Project Name: ~~Proposed~~ Hoppe Residence ~~Existing Deck Permit and C/O.~~

Street Address: Hoppe Residence - 8 Cara Drive, Nanuet NY 10954

DENIAL TO THE ZONING BOARD OF APPEALS

Proposed Project Description: Existing Rear Wood Deck and Trellis above for permit and C/O.

SITE LOCATION PLAN

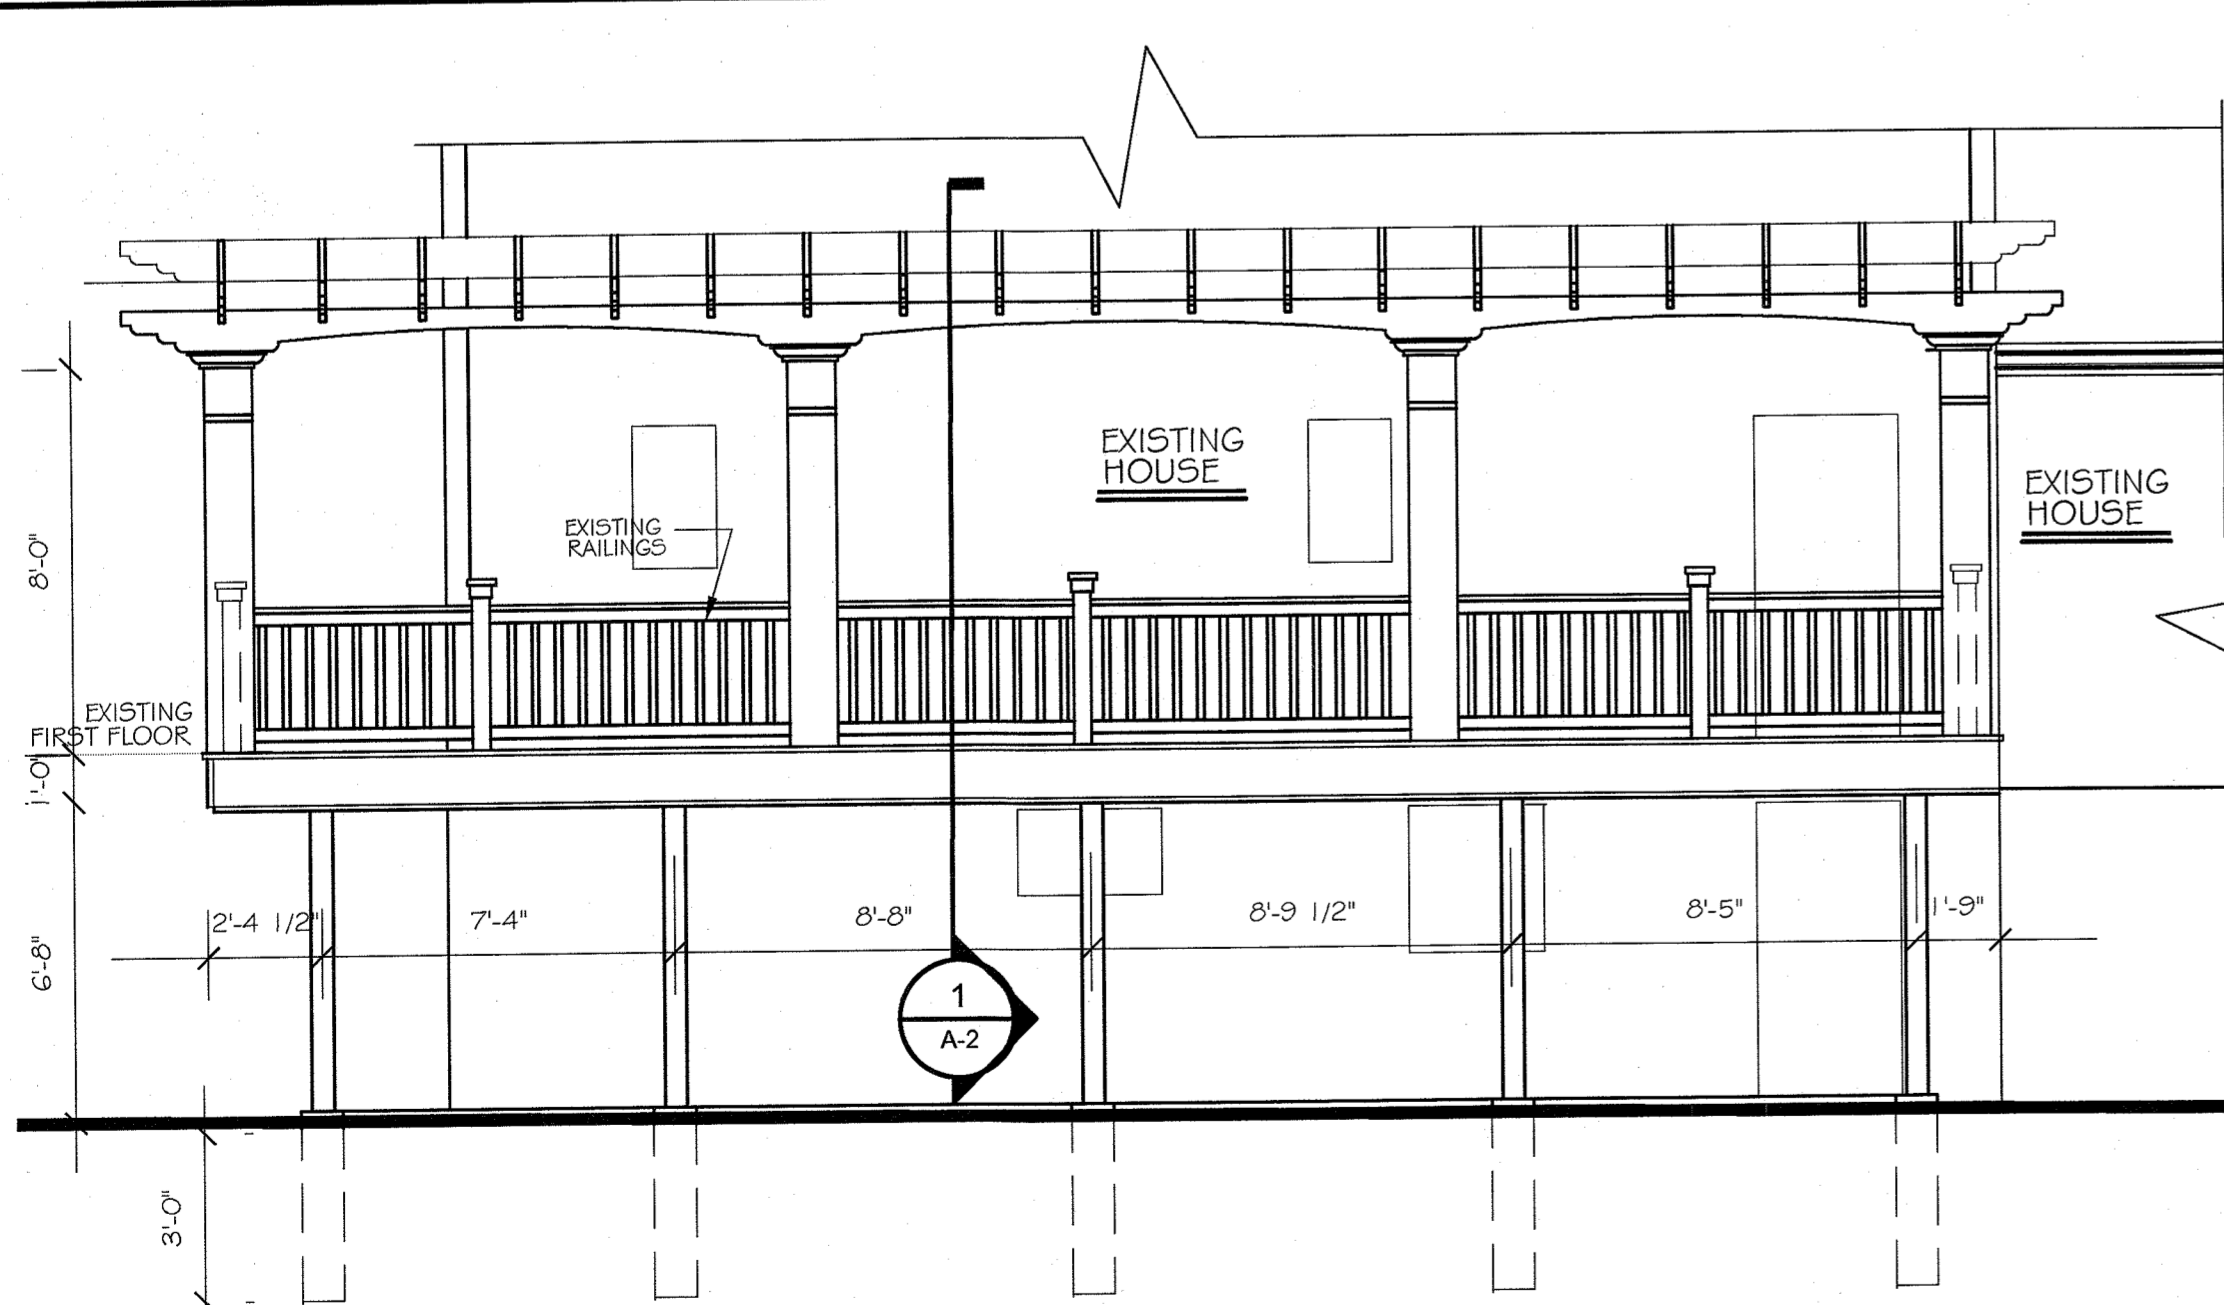
Chapter 43
Section 5.21(c) Undersized lot requires 15' side yard and 30' total side yard
Table 3.12, Column 1 R-15 District, Column 2 Group M, Column 3 SFR, Column 9 Required Side Yard
15' w/ 9'10" proposed and 15'4" proposed, Column 10 Total; side Yard 30' w/ 25'2" proposed
~~Three~~ variances required

Chapter 43
Section 5.21(c) Undersized lot requires 15' side yard and 30' total side yard
Table 3-12 Bulk Del, R-15 District, Col 2 Group M, Col 3 SR, Column 9
15' Required side yard w/ 9'10" proposed and 15'4" proposed, Column 10
Total Side Yard 30' w/ 25'2" proposed.
